19925 DAVIDSON-CONCORD RD

Mecklenburg County
Health Department

Re: Davidson-Concord Road
File: 3836B
Parcel: 007-281-06PO

SOIL/SITE EVALUATION
for ON-SITE WASTEWATER SYSTEM

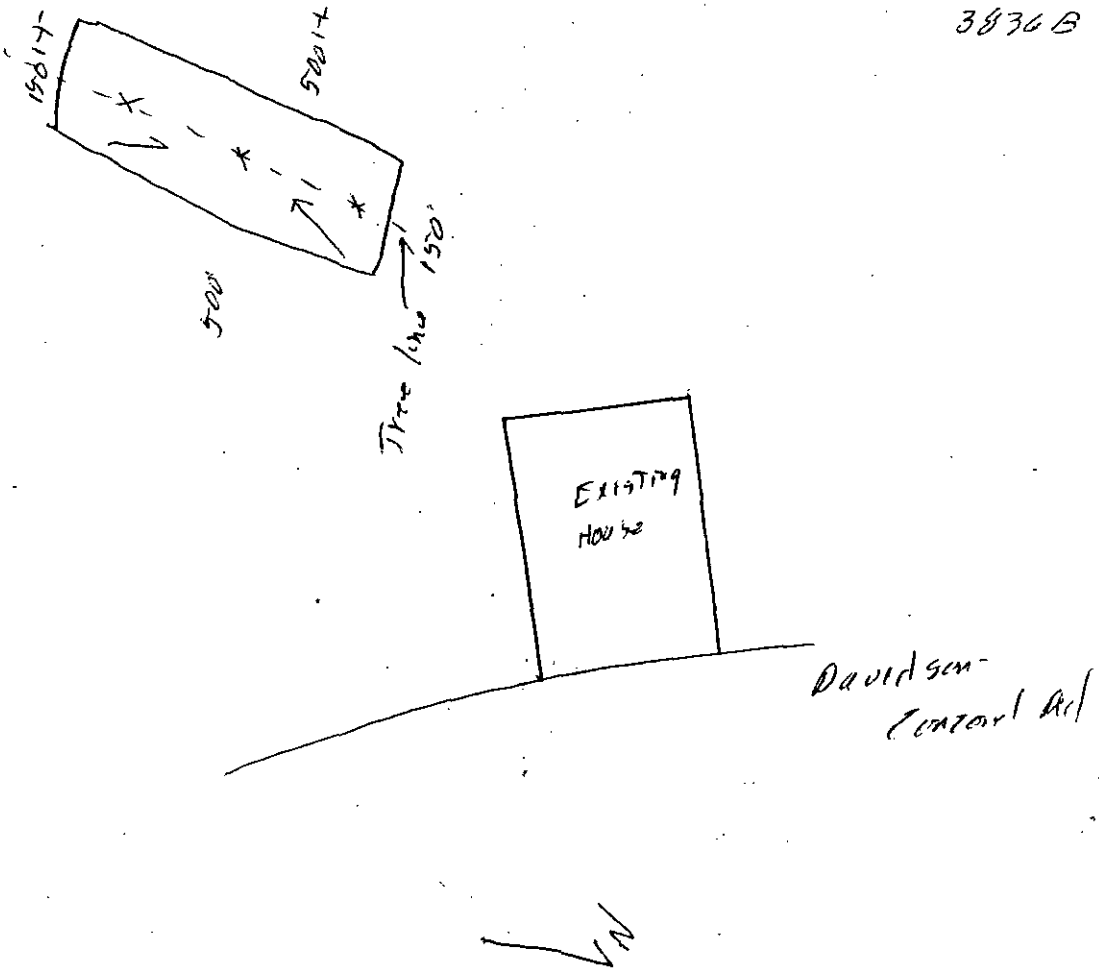
PROFILE #	1940 LANDSCAPE POSITION/ SLOPE %	HORIZON DEPTH (IN.)	SOIL MORPHOLOGY (.1941) 1941 STRUCTURE/ TEXTURE	1941 CONSISTENCE/ MINERALOGY	OTHER PROFILE FACTORS 1942 SOIL WETNESS/ COLOR	1943 SOIL DEPTH	1956 SAPRO CLASS	1944 RESTR HORIZ	PRC CI & I
1	convex slope 4%	0-3"	SBK/scl	Fr/SEXP/ss/sp	No Chroma 2 to 11"	11"	N/A	None	us
		3-11"	sc/structureless	Fr/SEXP/ss/sp					
2	Concave slope 3%	0-8"	SBK/scl	Fr/SEXP/ss/sp	2.5Y 7/1 Mottles @ 21"	24"	N/A	None	us
		8-24"	SBK/c	Fi/EXP/vs/vp					
3	Convex slope 4%	0-16"	SBK/sc	Fi/EXP/vs/vp	No Chroma 2 to ~~24~~ 16"	16"	N/A	None	us
4	Convex slope	0-6"	SBK/scl	Fr/SEXP/ss/sp	No Chroma 2 to 30"	30"	N/A	None	us
		6-30"	SBK/sc	Fi/EXP/vs/vp

OTHER FACTORS (.1946):
SITE CLASSIFICATION (.1948): Unsuitable
EVALUATED BY: William A. Mundy 1-5-96

SOIL/SITE EVALUATION
for ON-SITE WASTEWATER SYSTEM

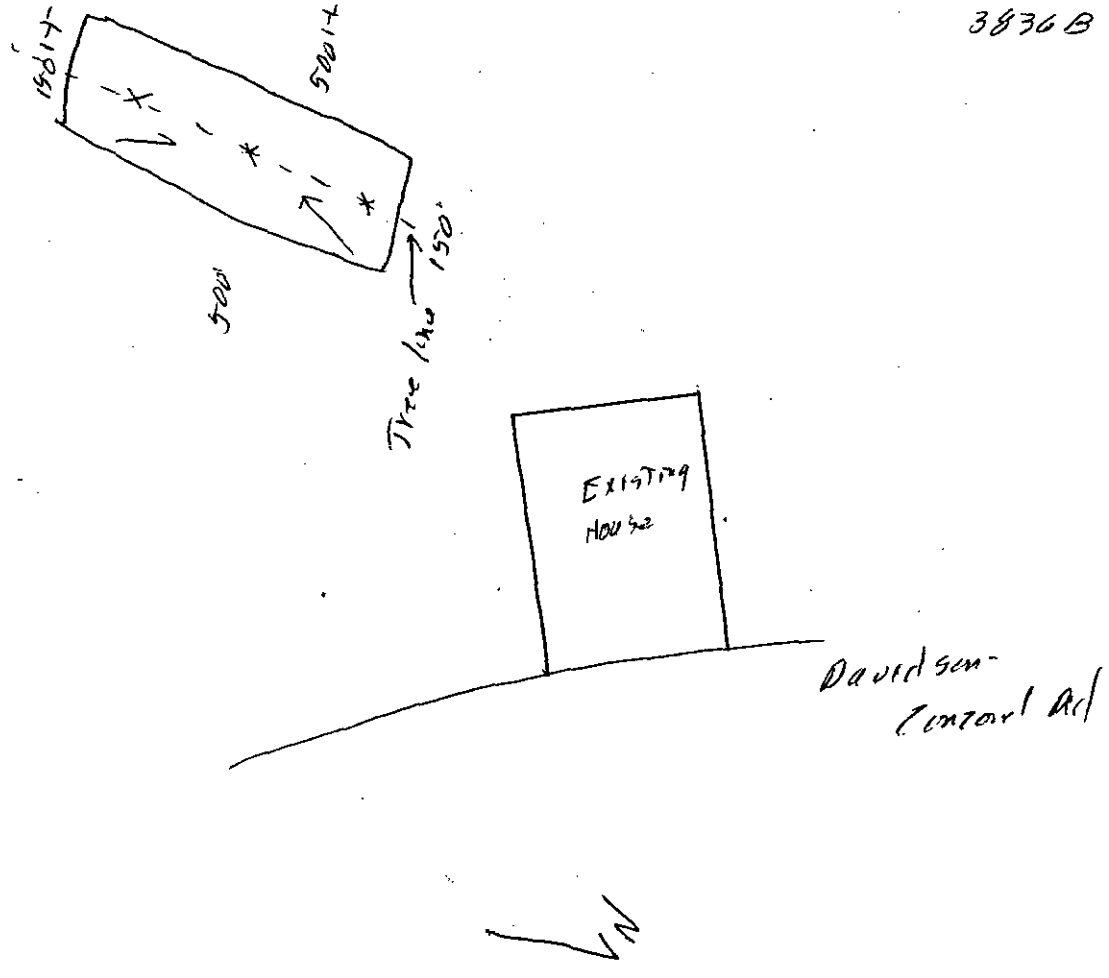
PROFILE #	.1940 LANDSCAPE POSITION/ SLOPE %	HORIZON DEPTH (IN.)	SOIL MORPHOLOGY (.1941) .1941 STRUCTURE/ TEXTURE	.1941 CONSISTENCE/ MINERALOGY	OTHER PROFILE FACTORS .1942 SOIL WETNESS/ COLOR	.1943 SOIL DEPTH	.1956 SAPRO CLASS	.1944 RESTR HORIZ	PROP CL & L
1	convex slope 4%	0-3"	SBK/scl	Fr/SEXP/ss/SP	No Chroma 2 to 11"	11"	N/A	None	US
		3-11"	sc/structureless	Fr/SEXP/ss/SP					
2	Concave slope 3%	0-8"	SBK/scl	Fr/SEXP/ss/SP	2.5Y 7/1 Mottles @ 21"	24"	N/A	None	US
		8-24"	SBK/c	Fi/EXP/vs/VP					
3	Convex slope 4%	0-16"	SBK/sc	Fi/EXP/vs/VP	No Chroma 2 to 16"	16"	N/A	None	US
4	Convex slope	0-6"	SBK/scl	Fr/SEXP/ss/SP	No Chroma 2 to 30"	30"	N/A	None	US
		6-30"	SBK/sc	Fi/EXP/vs/VP

OTHER FACTORS (.1946): ___
SITE CLASSIFICATION (.1948): Unsuitable
EVALUATED BY: William A. Meade 1-5-96
OTHER(S) PRESENT: ___
